**FINAL**  
**Revised Evaluation of**  
**Existing Interim Remedial Measures**  
**and Work Plan for Implementation of**  
**Future Interim Remedial Measures**  
**Sherwin-Williams Facility**  
**Emeryville, California**

**August 7, 1998**  
**6215.00-015**

**Subject: Final Report of Revised Evaluation of Existing Interim Remedial Measures and Work Plan for Implementation of Future Interim Remedial Measures, Sherwin-Williams Facility, Emeryville, California**

**Responses to Comments on the Draft Final Evaluation of Existing  
Interim Remedial Measures and Work Plan for Implementation of  
Future Interim Remedial Measures, dated May 20, 1998**

Figure 2-2

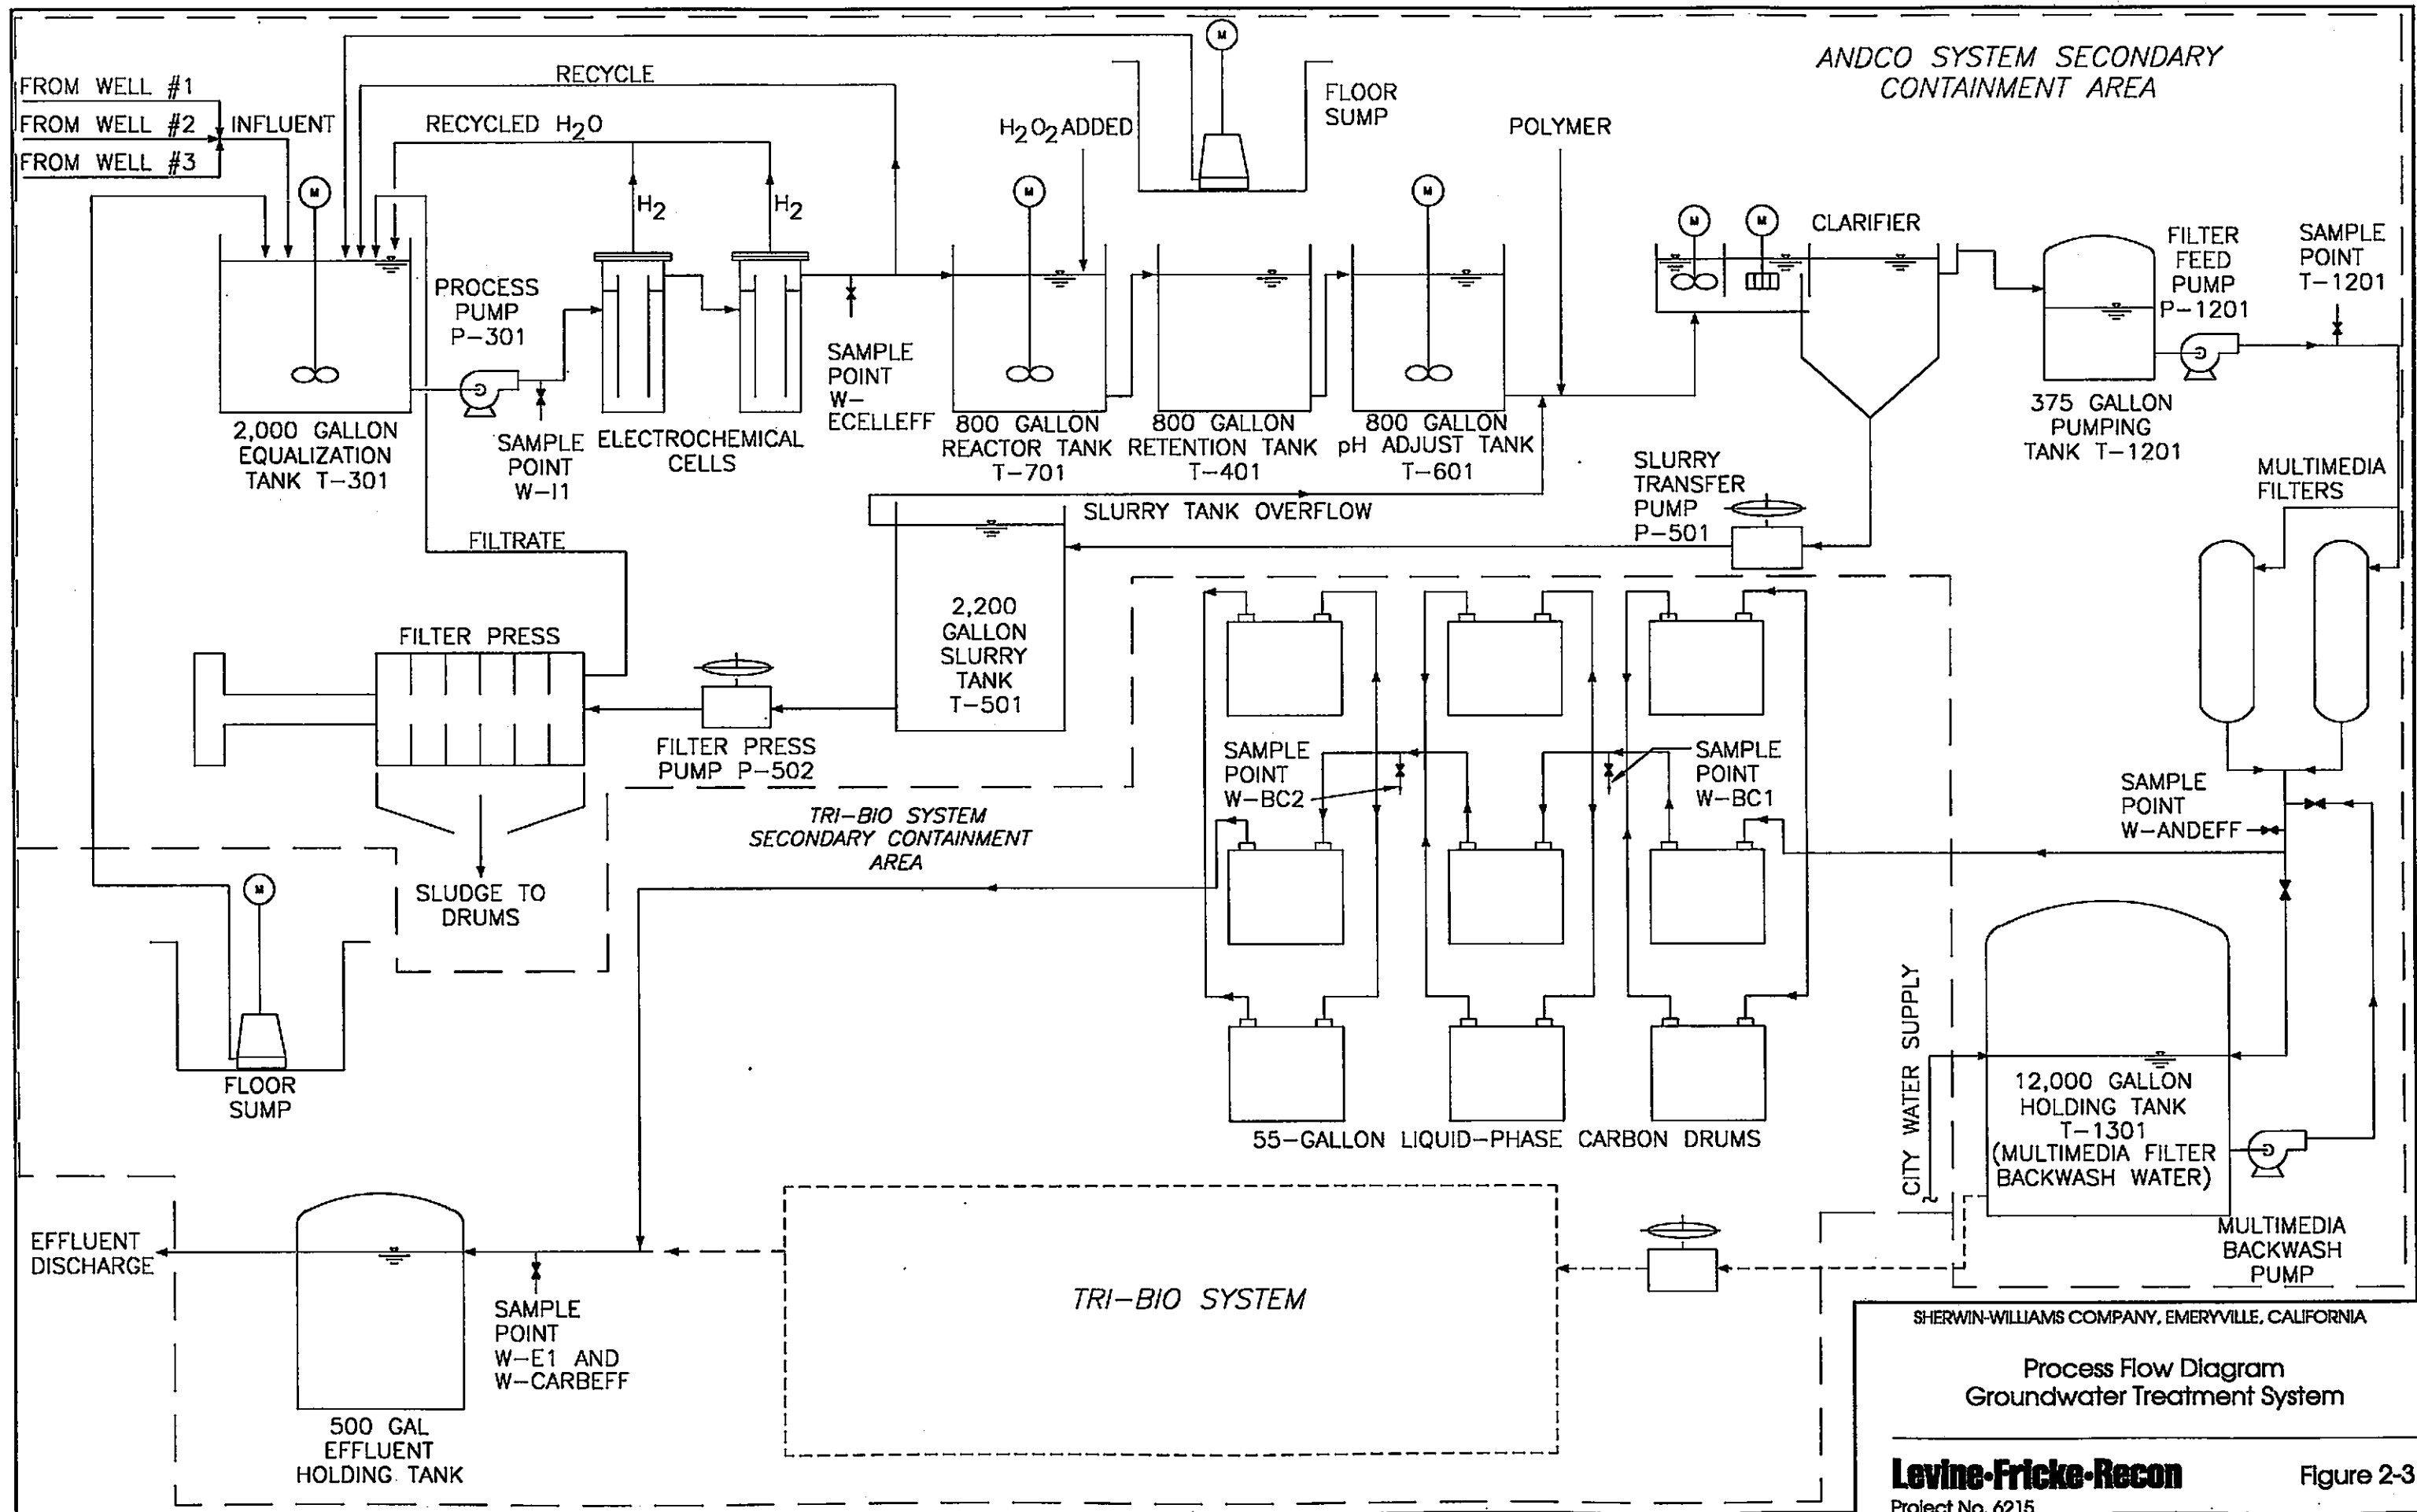
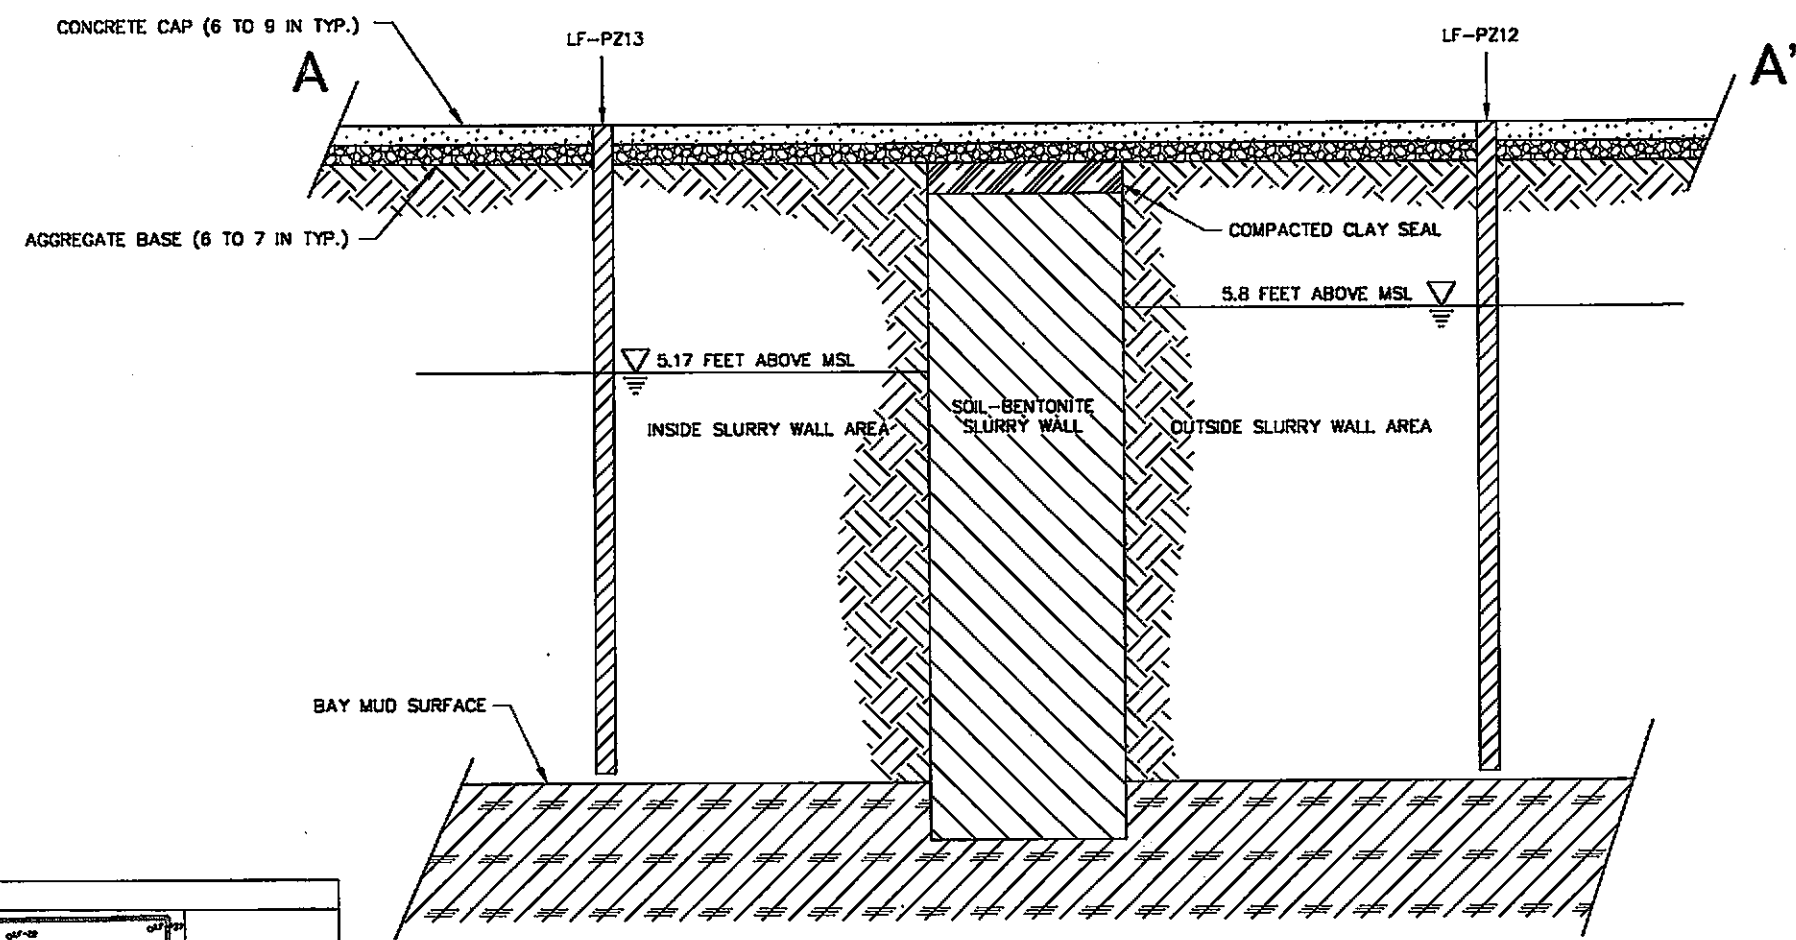
- 3. Figure 4 and Section 2.2.1 describe suspected areas where surface waters may be infiltrating the cap. The City understands that the cap is composed of a concrete asphalt layer. Are the cap and underlying soils structurally able to support foot/vehicle traffic loads and Baker tanks – and could these be causes of infiltration? The report states that a “superficial” inspection of the cap was conducted. Will a more extensive inspection of the cap be conducted? What are the criteria for measuring stability?**

Figure 3-2

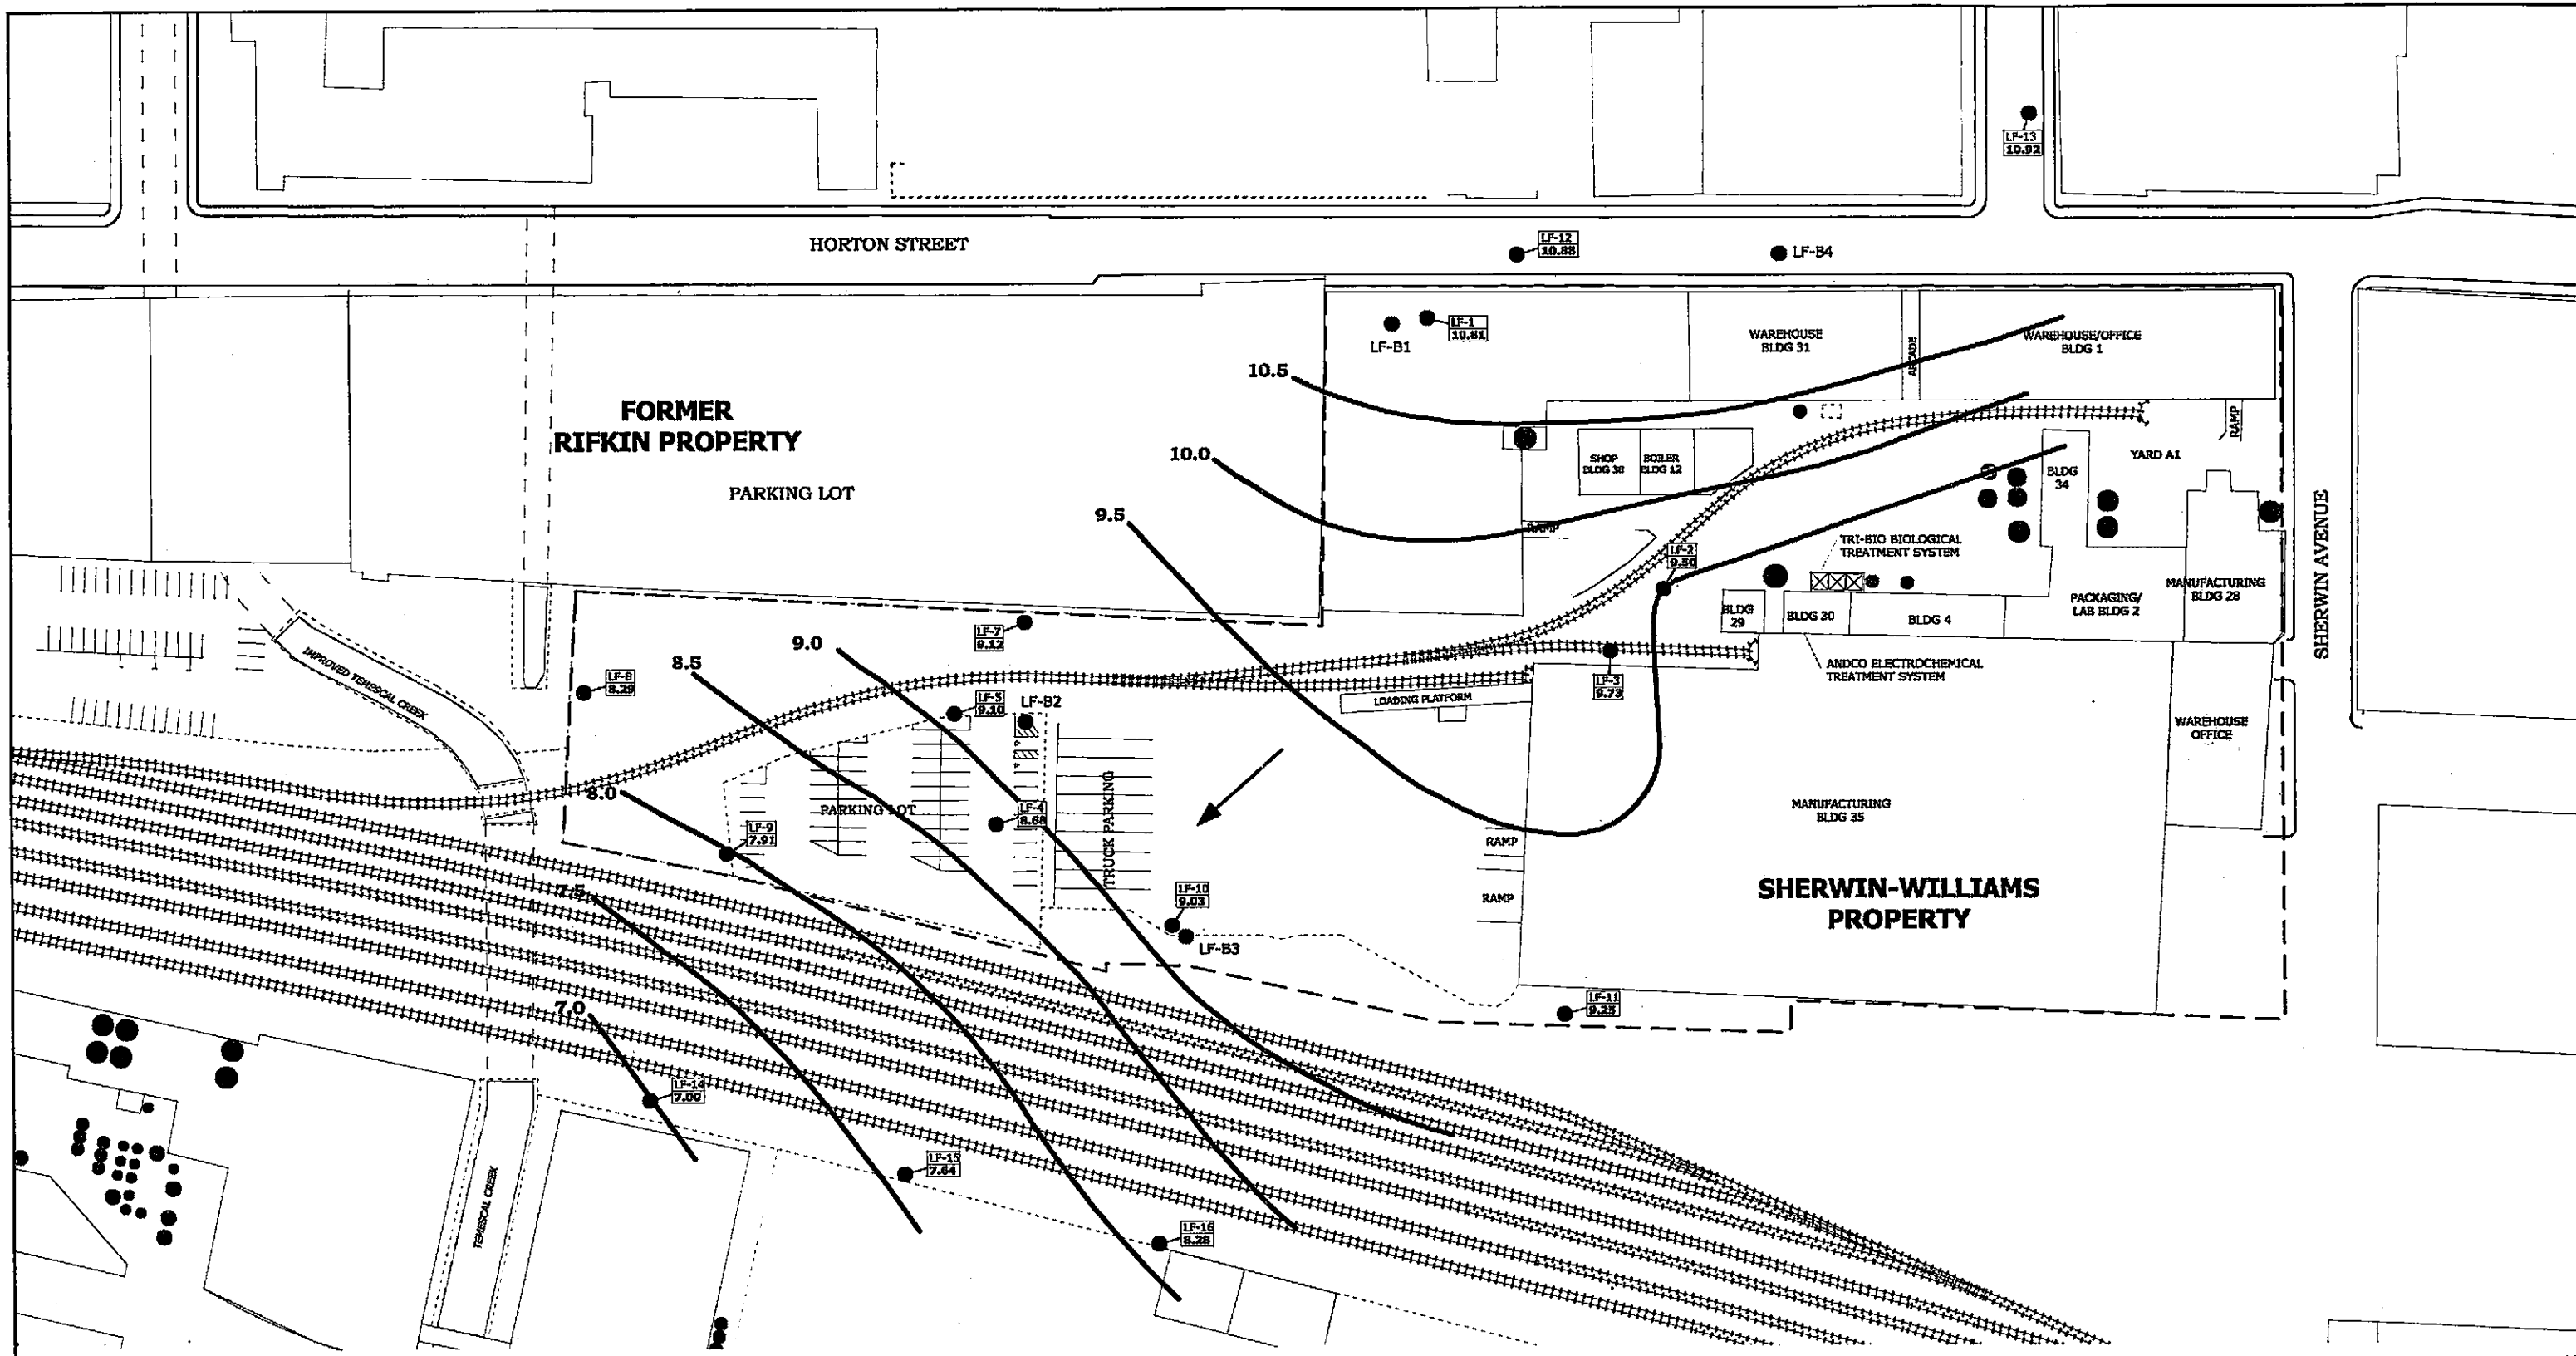
1. **Please provide a conceptual graphic(s) depicting existing and ideal differences in water elevations on both sides of the slurry wall, depths of the water bearing zones, elevations at points of extraction, storm drains and other man-made conduits.**

A figure has been added showing a cross section of a 320-foot portion of the storm drain system (Figure 3-2) that shows April and July 1998 water levels and their relation to the invert depths of the catch basins and storm-water system. Extraction wells EX-1 and EX-2 are projected onto the cross section and indicate groundwater elevations for these two wells.
